CONTRACT CHANGE ORDER NO. ____
SHEET ____ OF ____

SAN FRANCISCO OAKLAND BAY BRIDGE
EAST SPAN SEISMIC SAFETY PROJECT
SELF-ANCHORED SUSPENSION BRIDGE
(SUPERSTRUCTURE & TOWER)

HINGE A DETAILS NO. 1

SECTION A-A
(Orientation of Expansion Joint shown for Eastbound, see Note 10)
1:40

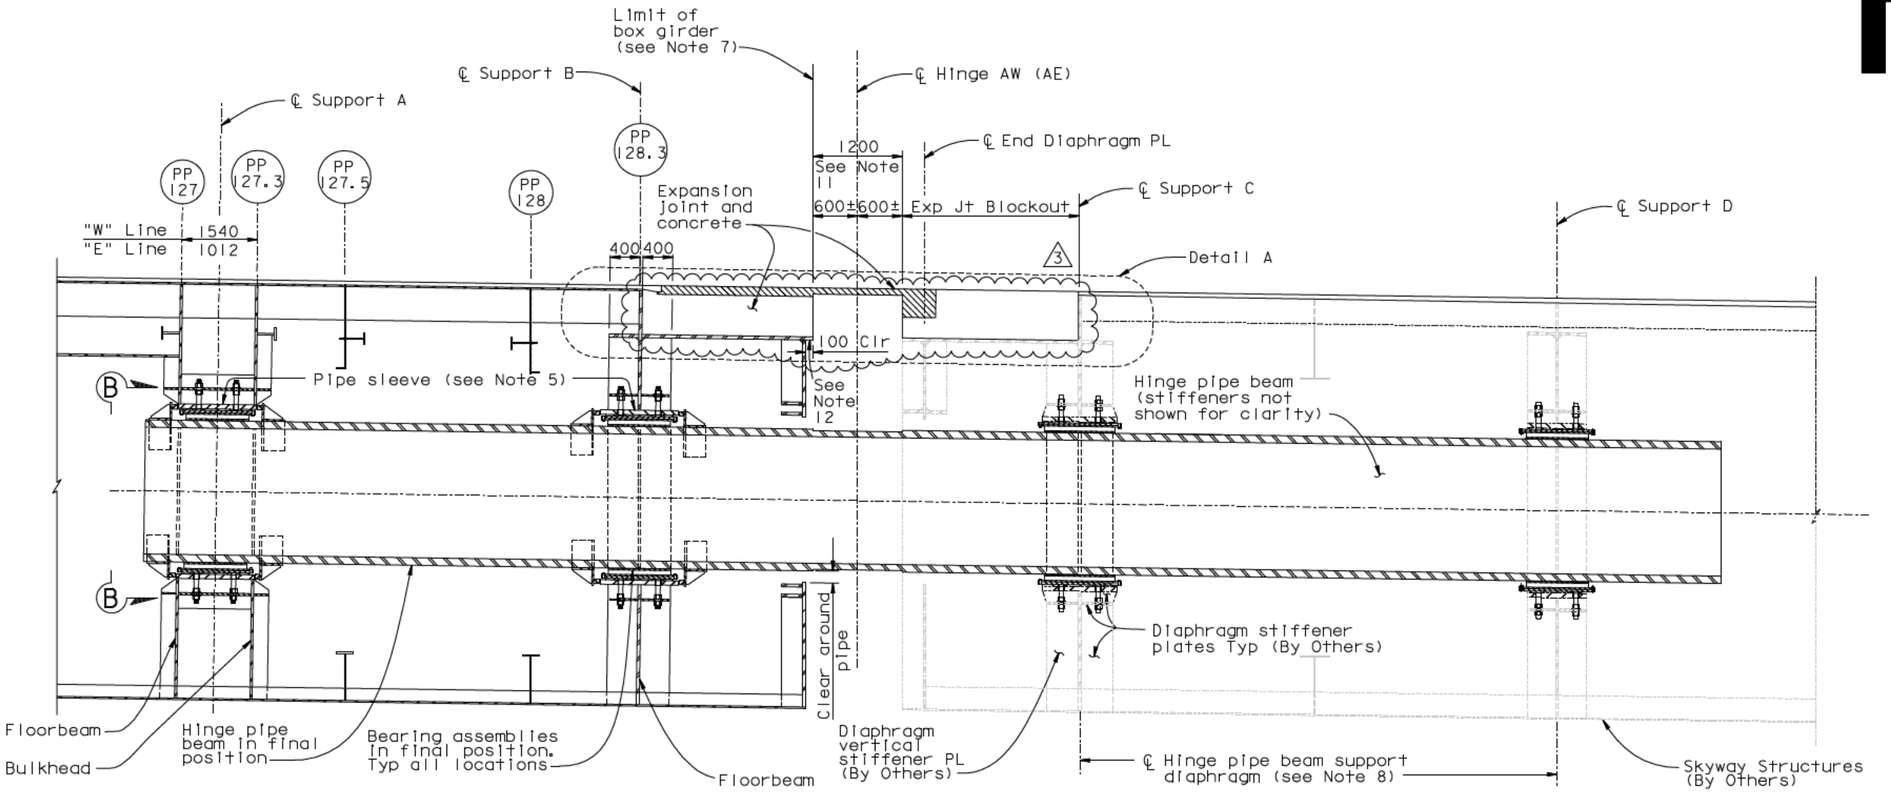
10. For orientation of expansion joints, see "Hinge A Expansion Joint Details" plans. (3)
11. The as-built gap at Hinge A shall be 1200 minimum. The limit of the concrete blockout shall be adjusted based on the field conditions of the Skyway.

12. The Contractor shall trim the blockout end PL and blockout bottom PL to maintain an expansion gap of 1200 minimum.
